For Official Use Only 請勿填寫此欄	Application No. 申請編號	A/TKO/123
	Date Received 收到日期	17 JUL 2021

Application No. 申請編號	(For Official Use Only) (請勿填寫此欄)		
Location/address 位置/地址	LOT NO.146 IN D.D.224, HANG HAU, TSEUNG KWAN O, NEW TERRITORIES 新界將軍澳坑口丈量約份第224約地段第146號		
Site area 地盤面積	sq. m 平方米 <input type="checkbox"/> About 約 (includes Government land of 包括政府土地 sq. m 平方米 <input type="checkbox"/> About 約)		
Plan 圖則	DRAFT TSEUNG KWAN O OUTLINE ZONING PLAN NO.S/TKO/27 將軍澳分區計劃大綱草圖編號 S/TKO/27		
Zoning 地帶	GREEN BELT 綠化地帶		
Applied use/ development 申請用途/發展	SCHOOL (SECONDARY AND/OR PRIMARY SCHOOL) 學校(中學及/或小學)

**APPLICATION FOR PROPOSED "SCHOOL" USE IN "GREEN BELT" ZONE, AT LOT  
146 IN D.D.224, TSEUNG KWAN O, HANG HAU, NEW TERRITORIES  
Town Planning Application No. A/TKO/123 – Further Information (1)**

Title	Prepared By	Date	Scale	Location	Drawing No.
Buffer Separation between the Subject Site and Chimney Stack of Tseung Kwan O Hospital	 DeSPACE (International) Limited	January, 2022	See Above	Lot No. 146 in D.D.224, Haug Hau, Tseung Kwan O, New Territories	Figure 2

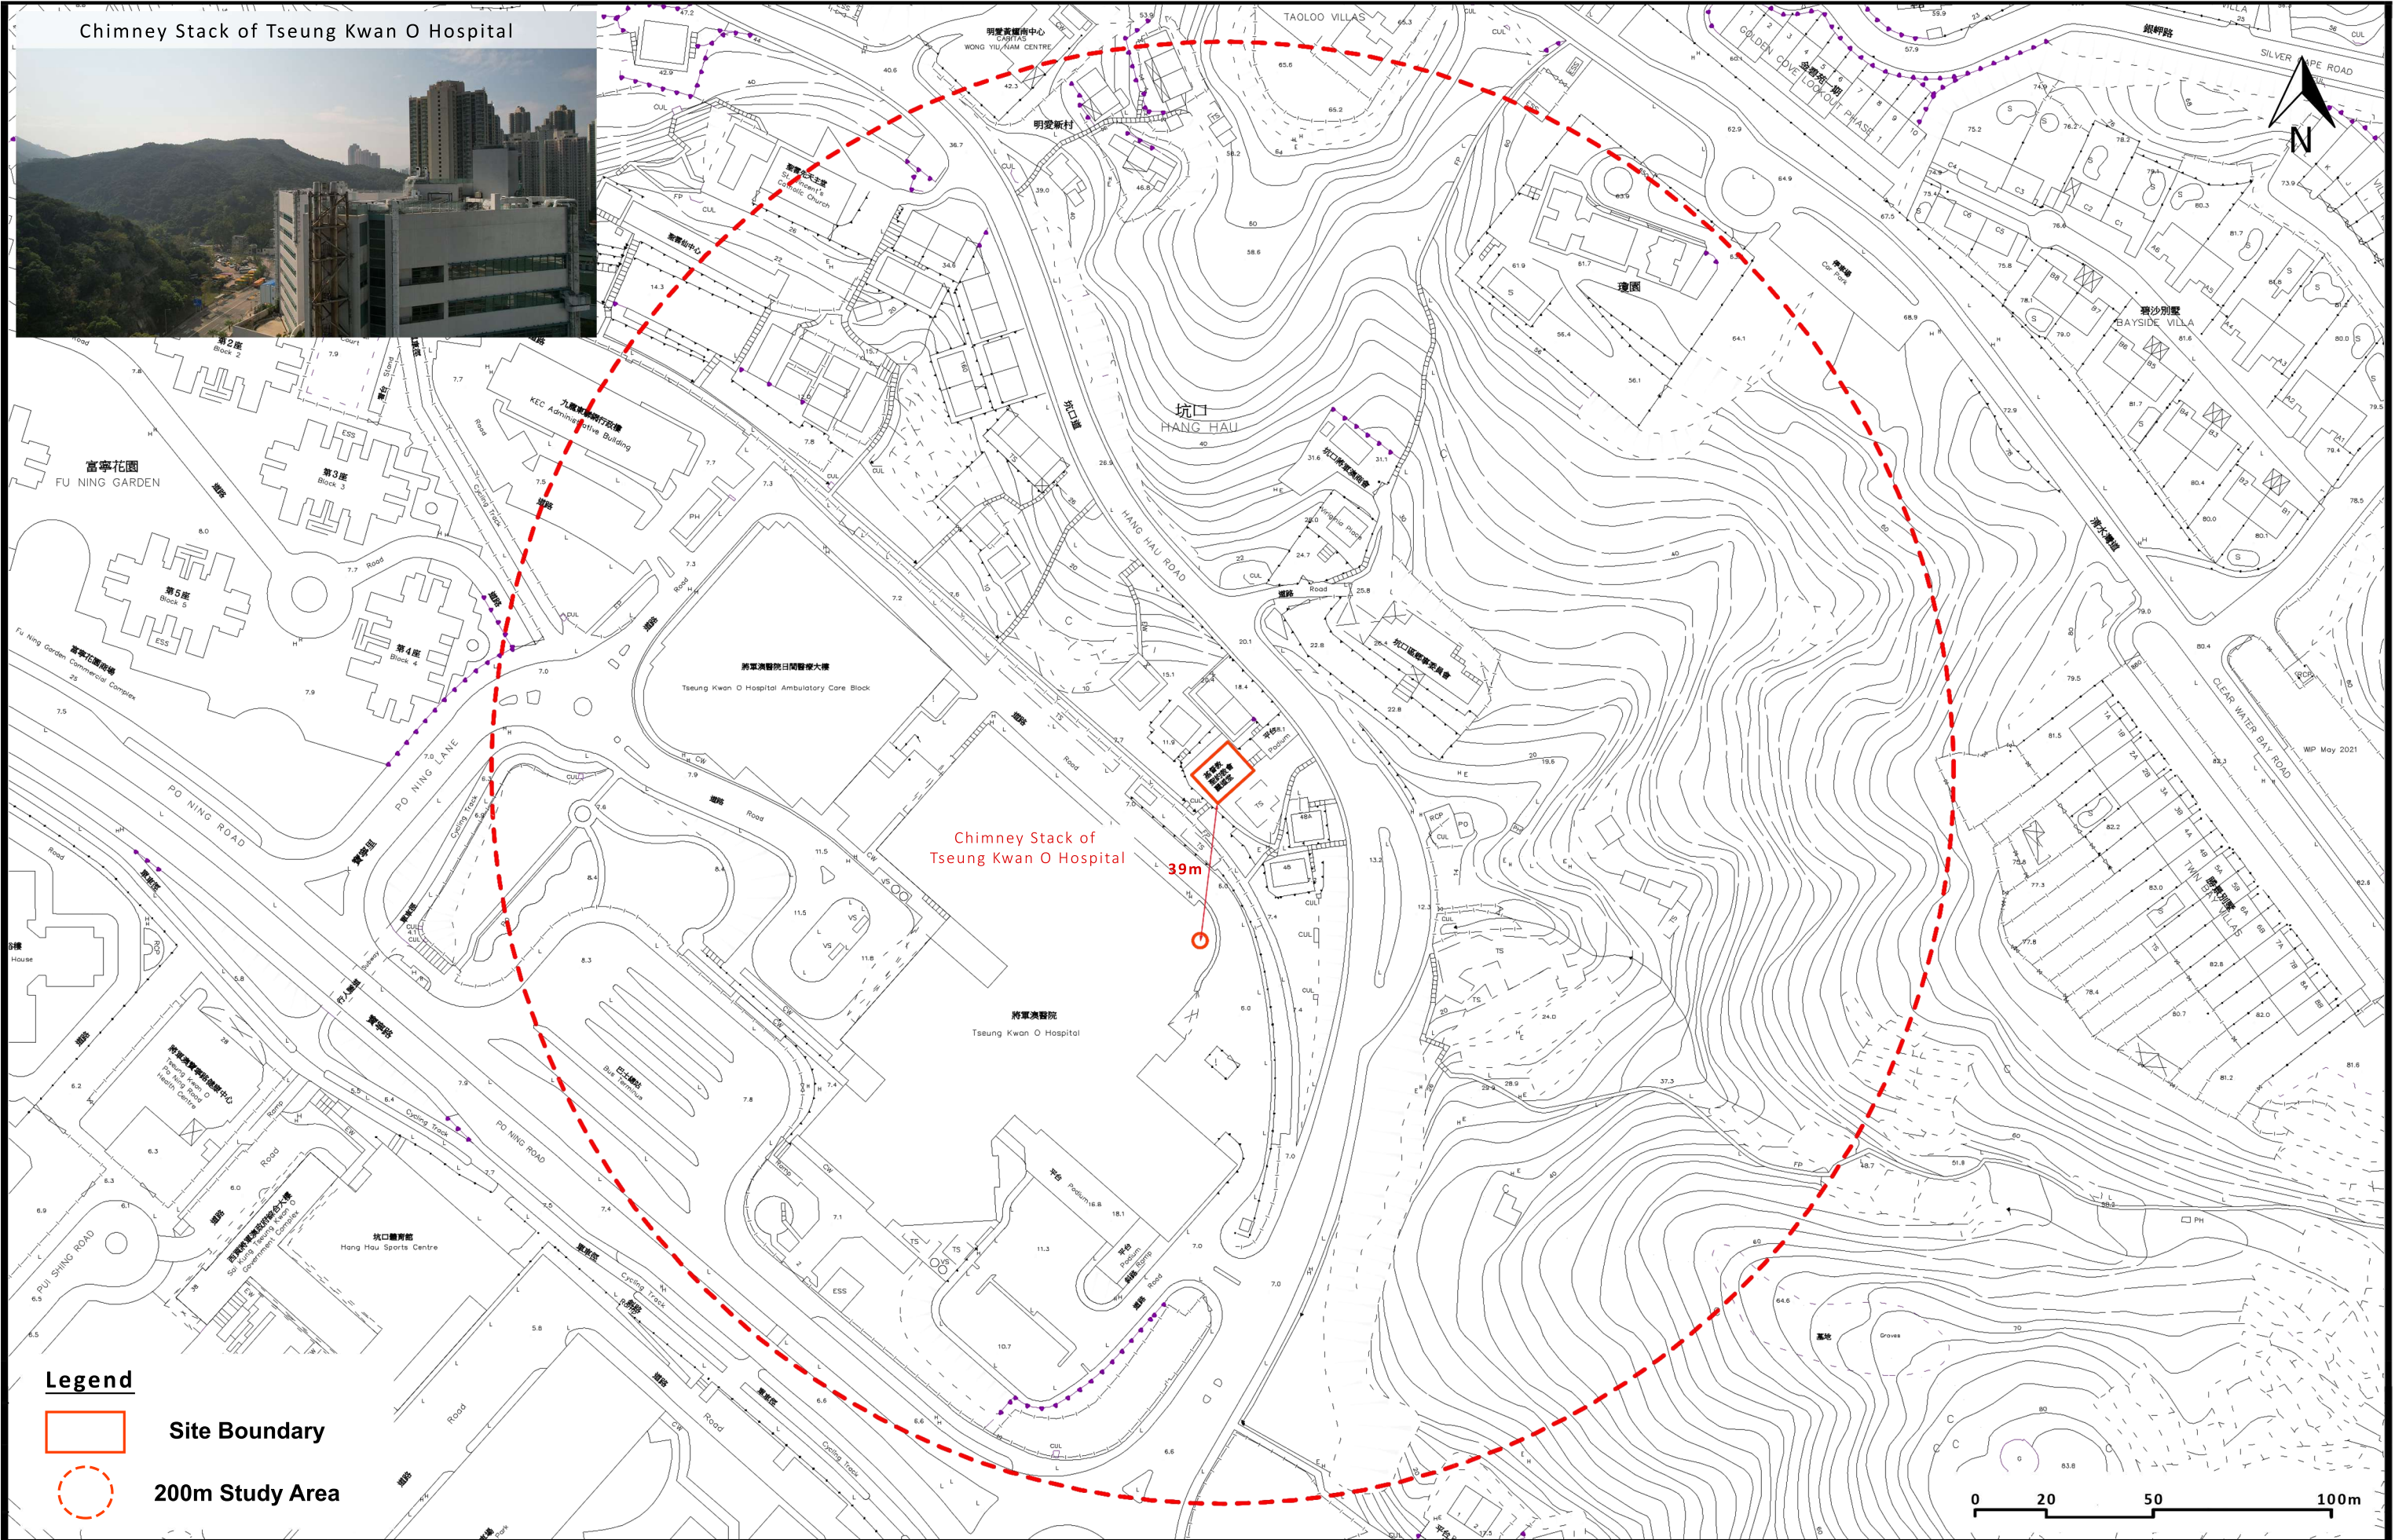
<p>4. S.1.3 –</p> <p>(a) The chimney height information of Tseung Kwan O Hospital should be confirmed by relevant parties, e.g. the Hospital, Buildings Department, etc. Please provide the confirmation and relevant correspondence for reference. The building height of the development should also be validated.</p>	<p>The request for the chimney height information of Tseung Kwan O Hospital has been sent to the Hospital and Buildings Department. The relevant correspondence will be provided to your office as soon as possible.</p> <p>The drone photo has been taken at the rooftop (at 19.78mPD) of the proposed development to estimate the vertical distance between the proposed development and chimney exist level. The result indicated that the 40m buffer separation is fulfilled.</p>

(b) Please clarify and confirm if the difference in the height between the chimney exit and the proposed development is more than 40m.	Please also note that the fixed window design with central air conditioning would be adopted and installed in the whole block of building. The fresh air intake point(s) can be located at G/F-2/F such that the 40m buffer separation can be well satisfied. An Authorised Persons will be appointed to select a proper location for fresh-air intake point(s) during design the subsequent detailed stage.
(c) Please note that a quantitative air quality assessment should be required to confirm the environmental acceptability if the buffer distance requirement for industrial chimney as stipulated in the HKPSG is not fulfilled.	Noted with thanks.

Departmental Comments	Response
<p><b><u>Supplementary information to email dated 17 Feb 2022 refers: EPD</u></b></p>	
<p>(a) The chimney height information of Tseung Kwan O Hospital should be confirmed by relevant parties, e.g. the Hospital, Buildings Department, etc. Please provide the confirmation and relevant correspondence for reference. The building height of the development should also be validated.</p>	<p>The request for the chimney height information on Tseung Kwan O Hospital has been acquired from Hospital Authority (HA). The difference in the height between the chimney exit and the proposed development is confirmed to be more than 40m. The Applicant undertakes to confirm the validity of this information. Given the current surge of COVID-19 cases, it is reasonably to spend time for the formal reply. To this end, if EPD considers fit, the Applicant is ready to accept an approval condition on this aspect. Once the formal written confirmation is obtained, the Applicant shall then submit to apply to discharge this approval condition.</p>

<p>(b) Please clarify and confirm if the difference in the height between the chimney exit and the proposed development is more than 40m.</p>	<p>As an alternative, the Applicant can assist EPD to call the HA to further this chimney site information.</p>

As shown in the **Figure 2**, the horizontal separation distance from the nearest southern site boundary to the chimney emission sources of Tseung Kwan O Hospital Main Block is about 39m. Given that the proposed development is elevated to about 19.78 mPD, the difference in vertical elevation between the chimney exit level and the proposed development is about 40m. According to Table 3.1 of Chapter 9 of the HKPSG, with different in height >40m, a horizontal separation distance of >10m is required. As the nearest horizontal separation distance between the Site and chimney is well above 10m, the buffer separation required is satisfied.

**Plan 1. Location of Proposed Site and Identified NSR**

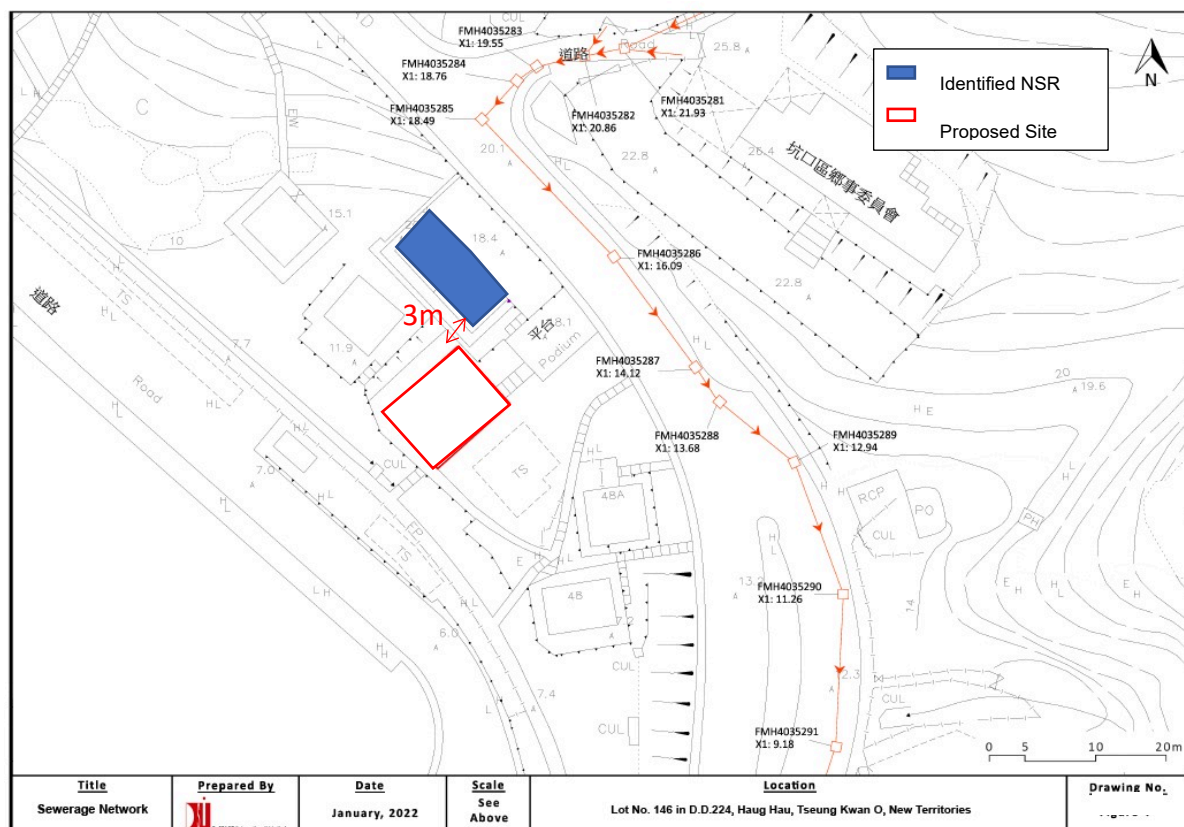
<p>3. S.2.2, 1st para. – The statement “According to HKPSG, all fixed noise sources should be so located and designed that when assessed ... Or Construction Sites”.” is not relevant to the assessment of existing fixed noise sources. Please remove this statement.</p>	<p>Noted with thanks. It is updated on <b>Section 2.2</b>.</p>
<p><b><u>Sewerage</u></b></p> <p>4. Please assess the sewerage impact to further downstream (e.g. to FMH4035232).</p>	<p>The PWP No. 4214DS – Tseung Kwan O sewerage for villages is under construction to provide public sewerage system for ten unsewered areas in Tseung Kwan O.</p> <p>Based on the information provided by the Binnies Hong Kong Limited (<b>Appendix 1</b>), the appointed consultant for the construction project, the sewage generated from the proposed development can be discharged to the manhole no. HL 005-2 along the footpath to the public sewerage system at manhole no. FMH4035229.</p> <p>It is noted that the new sewerage connection is designed to accommodate 30 persons for the subject site. As shown in the table below, the proposed school development will generate an additional flow of 1.74 m<sup>3</sup>/day, which is an insignificant figure.</p>

The nearest existing NSR (i.e. 3-storey residential building) from the proposed Site is presented in **Plan 1**. The horizontal distance from the proposed Site to the existing NSR is approximately 3m.

The information regarding the sound power level and the quantity of the unitary A/C unit is not available from project proponent at this time. The assessment approach is to specify a maximum cumulative allowable sound power level of the plant equipment which is determined by backward calculation with a known maximum allowable impact sound level i.e. the adopted criteria.

Title	Prepared By	Date	Scale	Location	Drawing No.
Location of the Representative Air Sensitive Receivers (ASRs)	 DeSPACE (International) Limited	February, 2022	See Above	Lot No. 146 in D.D.224, Haug Hau, Tseung Kwan O, New Territories	Figure 1

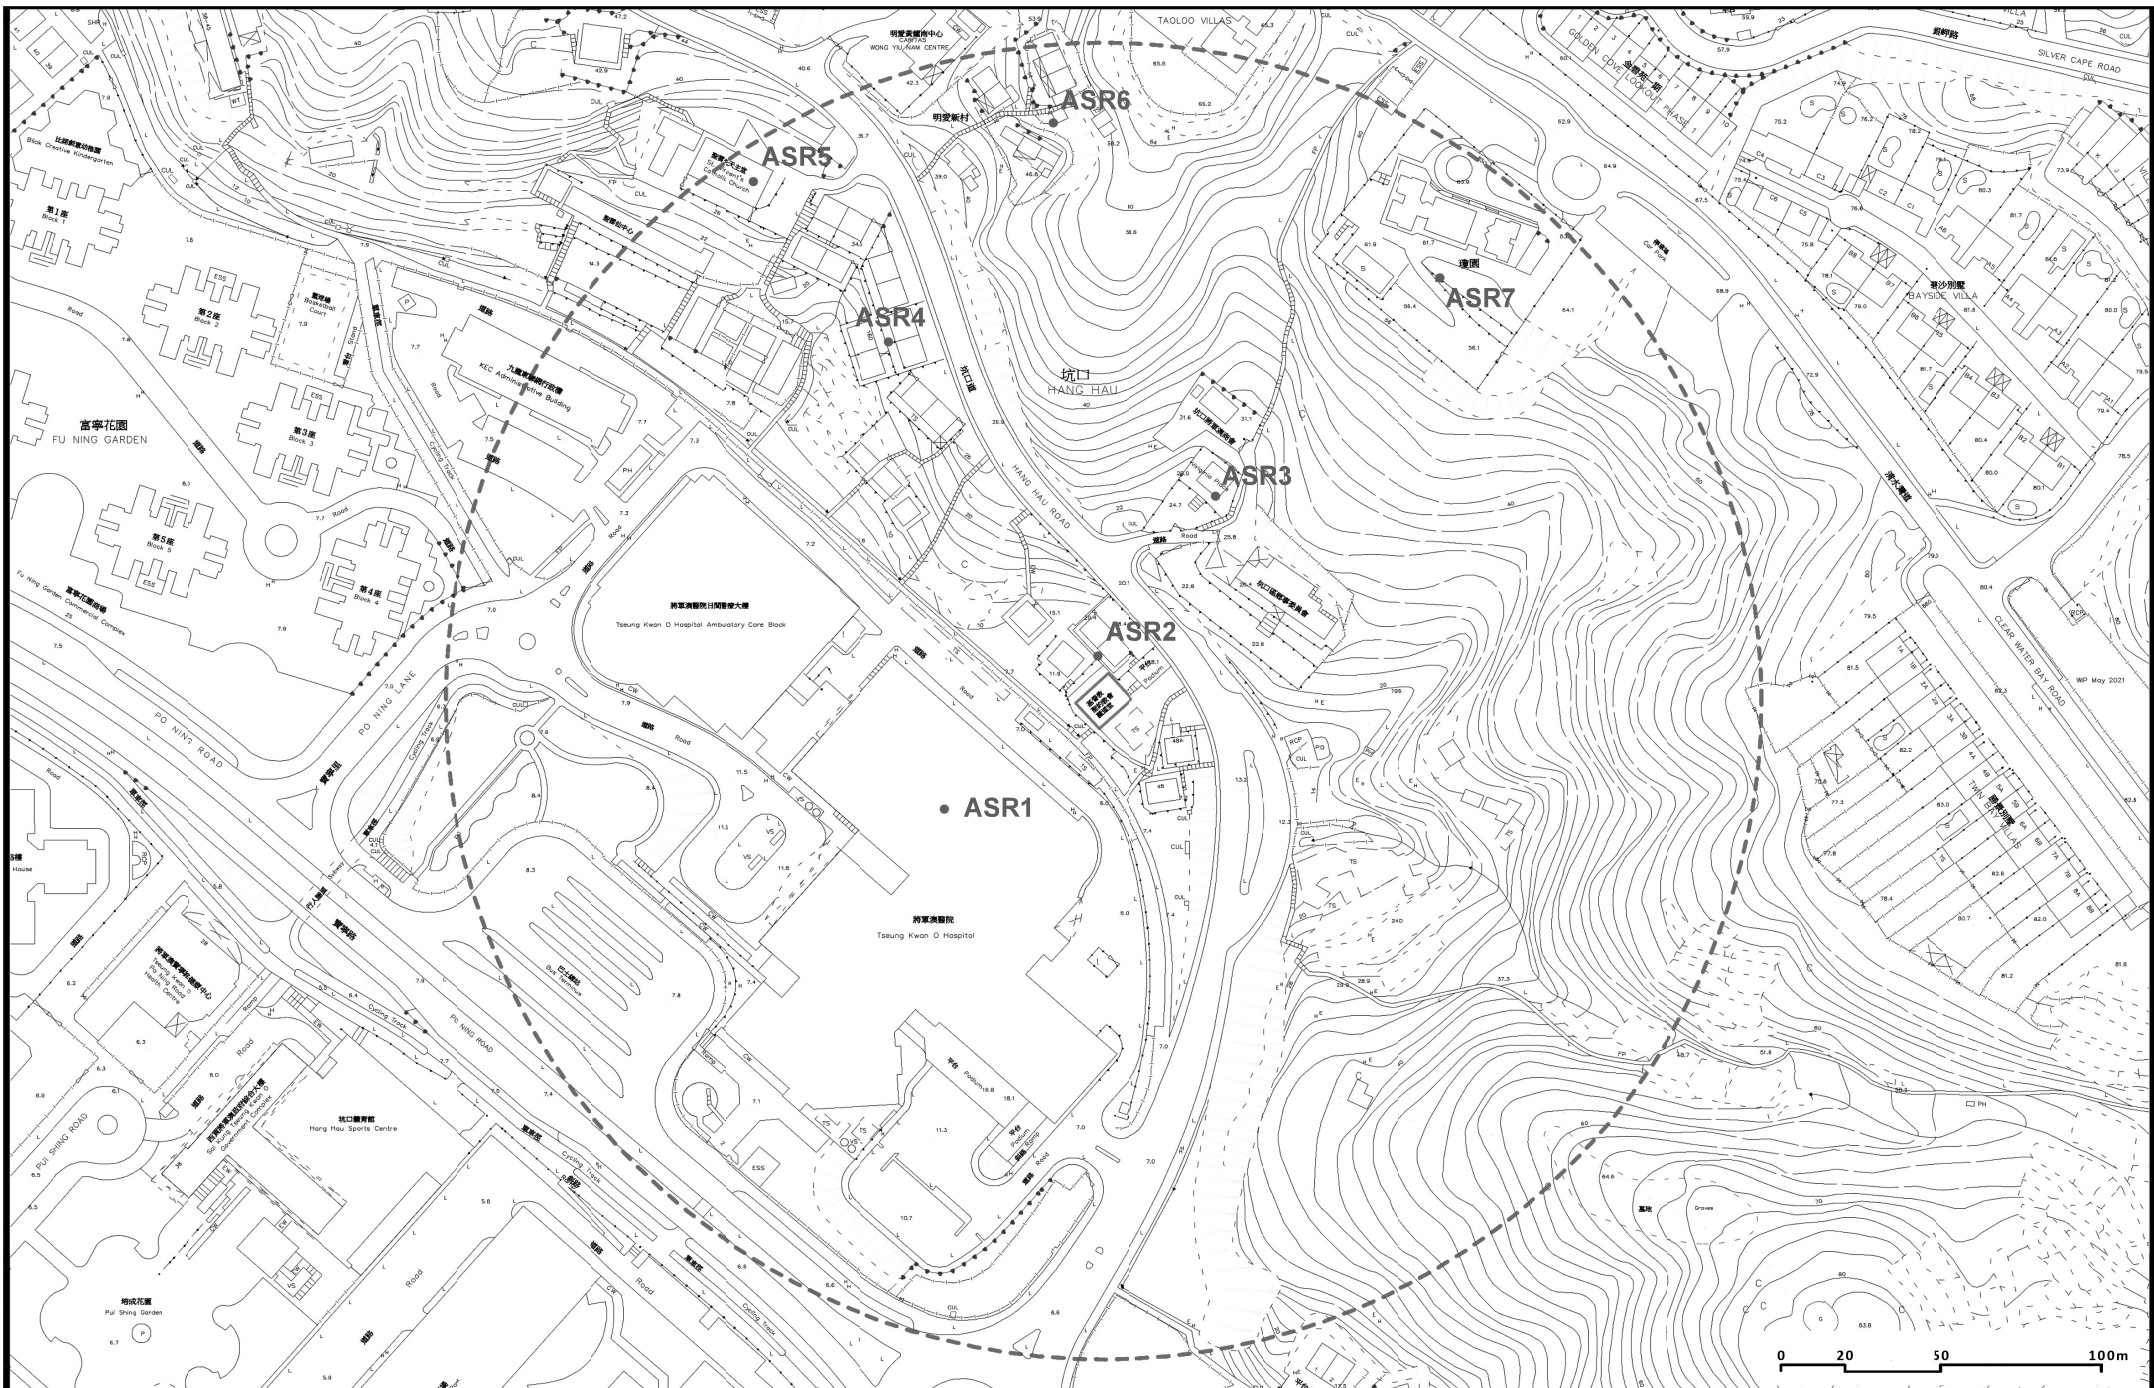
Departmental Comments	Response																																
<p><b><u>Email dated 17 Feb 2022 refers:</u></b></p> <p><b><u>EPD</u></b></p>																																	
<p><b><u>Air</u></b></p> <p>1. Please provide a list of representative ASRs in the assessment area, and include a map for indicating their locations.</p>	<p>Representative Air Sensitive Receivers (ASRs) in the vicinity of the subject Site have been identified and are summarised in Table 1.</p> <p><b>Table 1: Identified Representative ASRs</b></p>

<p>The identified representative ASRs are shown in <b>Figure 1</b>.</p>	ASR	Description	Type of use	Approximate Separation Distance from the Nearest Site Boundary	A1	Tseung Kwan O Hospital	Hospital	30m	A2	Village House of the Hang Hau Lower Old Village	Residential	3m	A3	Village House	Residential	65m	A4	Village House of the Hang Hau Lower Old Village	Residential	110m	A5	St Vincent’s Church	Church	180m	A6	Village House of the Ming Oi New Village	Residential	160m	A7	King Yuen	Residential	170m
ASR	Description	Type of use	Approximate Separation Distance from the Nearest Site Boundary																														
A1	Tseung Kwan O Hospital	Hospital	30m																														
A2	Village House of the Hang Hau Lower Old Village	Residential	3m																														
A3	Village House	Residential	65m																														
A4	Village House of the Hang Hau Lower Old Village	Residential	110m																														
A5	St Vincent’s Church	Church	180m																														
A6	Village House of the Ming Oi New Village	Residential	160m																														
A7	King Yuen	Residential	170m																														
<p>2. Please review the recent 5-year air pollutant concentrations with reference to the nearest EPD air quality monitoring station with a view to assessing the baseline air quality condition in the district concerned.</p>	<p>The Air Pollution Control Ordinance (Cap.311) provides the statutory authority for the management of air quality. The prevailing Air Quality Objectives (AQOs) stipulate the statutory limits of 7 air pollutants in the ambient air and the maximum allowable number of exceedances over the specific periods. The AQOs are presented in <b>Table 2</b>.</p>
